PIC24FJ256GA110 Family Silicon Errata and Data Sheet Clarification

The PIC24FJ256GA110 family devices that you have received conform functionally to the current Device Data Sheet (DS39905E), except for the anomalies described in this document.

Data Sheet Clarifications

The following typographic corrections and clarifications are to be noted for the latest version of the device data sheet (DS39905E):

FIGURE 2-3 FREQUENCY vs. ESR PERFORMANCE FOR SUGGESTED VCAP

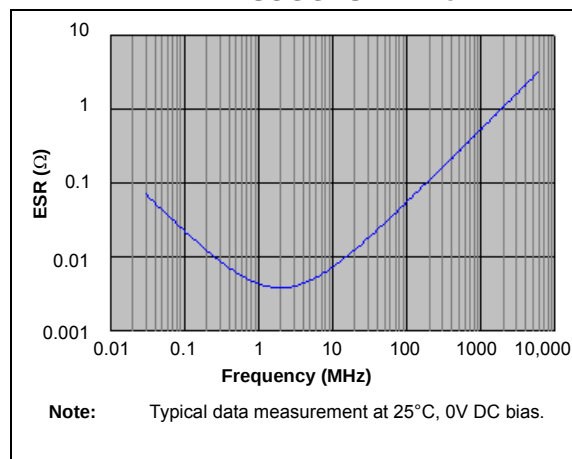
Section 2.4 Voltage Regulator Pins (ENVREG/ DISVREG and VCAP/VDDCORE) has been replaced with a new and more detailed section. The entire text follows:

When the regulator is enabled, a low-ESR ($< 5\Omega$) capacitor is required on the VCAP/VDDCORE pin to stabilize the voltage regulator output voltage. The VCAP/VDDCORE pin must not be connected to VDD and must use a capacitor of $10\mu\text{F}$ connected to ground. The type can be ceramic or tantalum. Suitable examples of capacitors are shown in [Table 2-1](#). Capacitors with equivalent specifications can be used.

Designers may use [Figure 2-3](#) to evaluate ESR equivalence of candidate devices.

FIGURE 2-4 DC BIAS VOLTAGE vs. CAPACITANCE CHARACTERISTICS

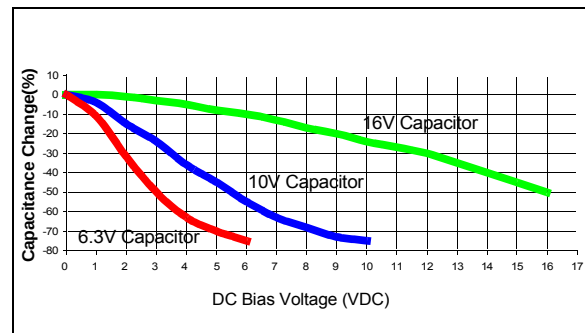
In addition to temperature tolerance, the effective capacitance of large value ceramic capacitors can vary substantially, based on the amount of DC voltage applied to the capacitor. This effect can be very significant, but is often overlooked or is not always documented.

A typical DC bias voltage vs. capacitance graph for 16V, 10V and 6.3V rated capacitors is shown in Figure 2-4.

When selecting a ceramic capacitor to be used with the internal voltage regulator, it is suggested to select a high-voltage rating, so that the operating voltage is a small percentage of the maximum rated capacitor voltage. For example, choose a ceramic capacitor rated at 16V for the 2.5V core voltage. Suggested capacitors are shown in Table 2-1.
